PUBLIC HEARING**2. SC25-0010 – Aditi Mukherjee – 524 Distel Drive**

Request for Design Review to construct a new 3,557 square-foot, two-story house. The project site is located on the west side of Distel Drive, between Jardin Drive and Alvarado Avenue. The project is categorically exempt from environmental review pursuant to Section 15303 (New Construction or Conversion of Existing Structures) of the California Environmental Quality Act (CEQA). *Project Planner: Gallegos*

ZONING ADMINISTRATOR AGENDA REPORT

TO: Nick Zornes, Zoning Administrator
FROM: Sean Gallegos, Senior Planner
SUBJECT: SC25-0010 – 524 Distel Drive

DRAWN AM
CHECKED
DATE 3.15.25
SCALE 1/8" = 1'-0"
JOB NO.
SHEET A1

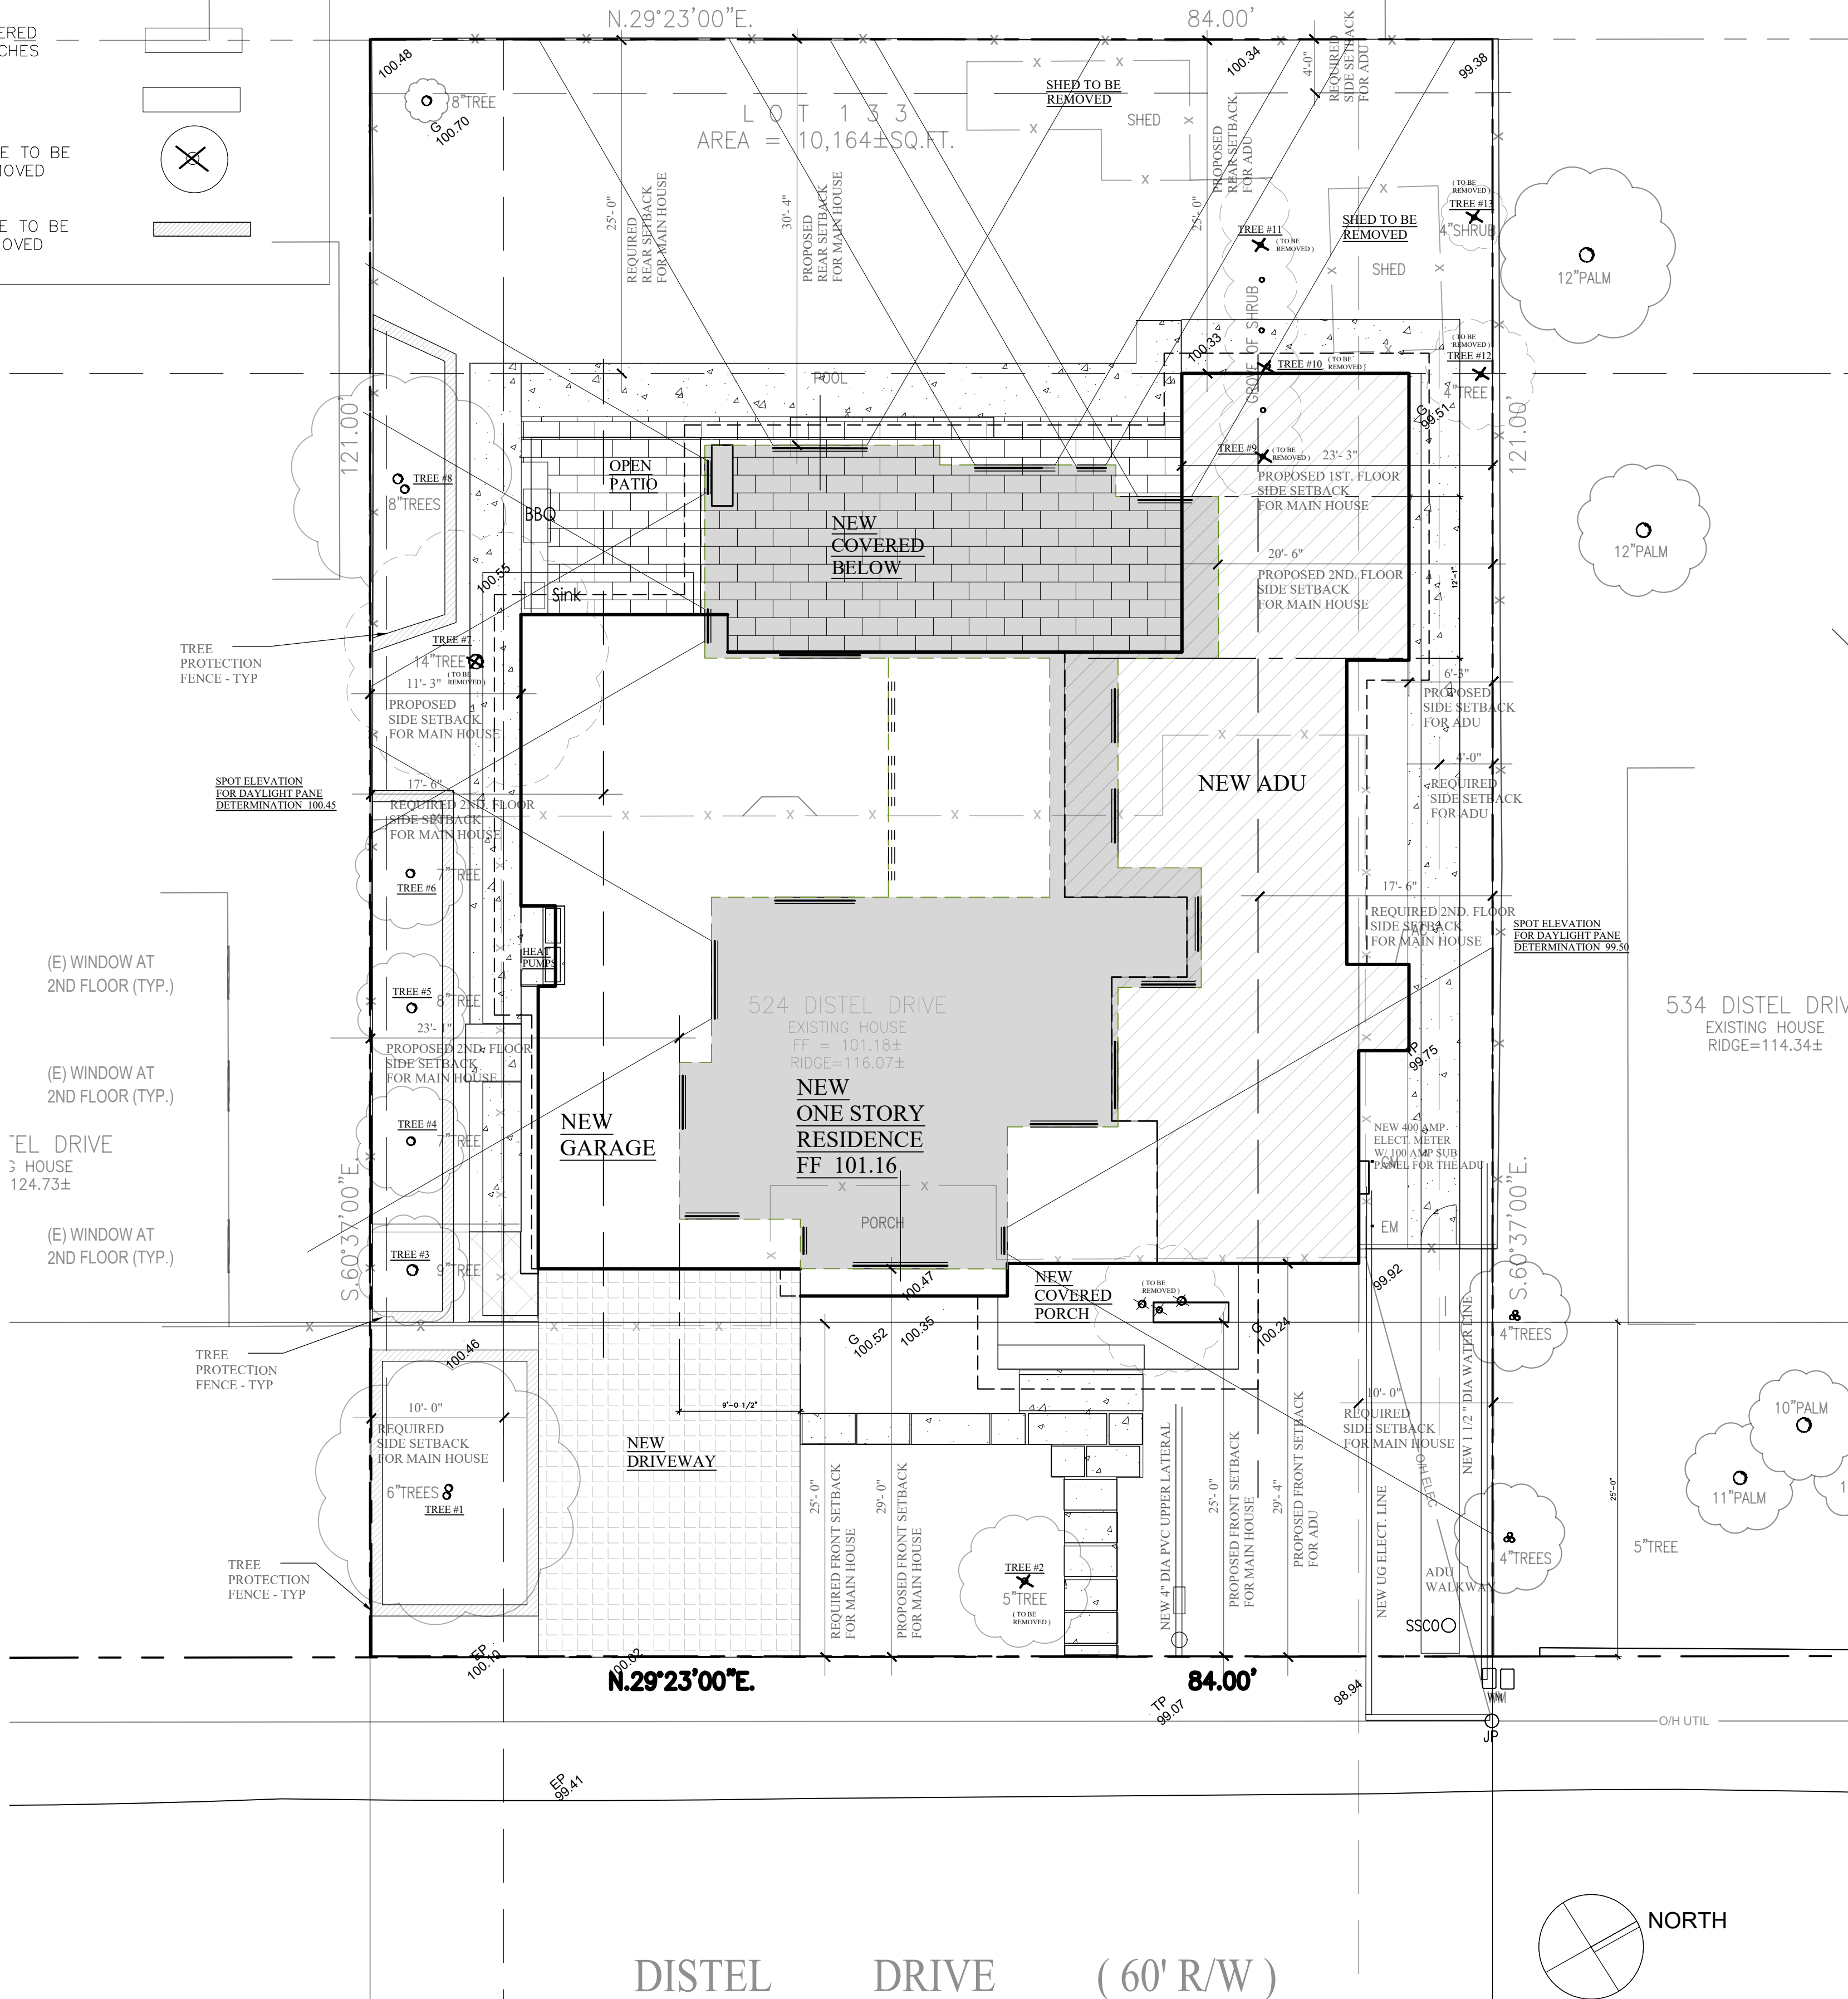
9. **Tree Removal Approved:** Trees Nos. 7 shown to be removed on plan Sheet A1 of the approved set of plans are hereby approved for removal. Tree removal shall not occur until a building permit is submitted and shall only occur after the issuance of a demolition permit or building permit. Exceptions to this condition may be granted by the Development Services Director upon submitting written justification.

36. **Fire Sprinklers Required:** An automatic residential fire sprinkler system shall be installed in accordance with National Fire Protection Association's (NFPA) Standard 13D in all new one and two-family dwellings. Sprinklers noted on sheet A1.
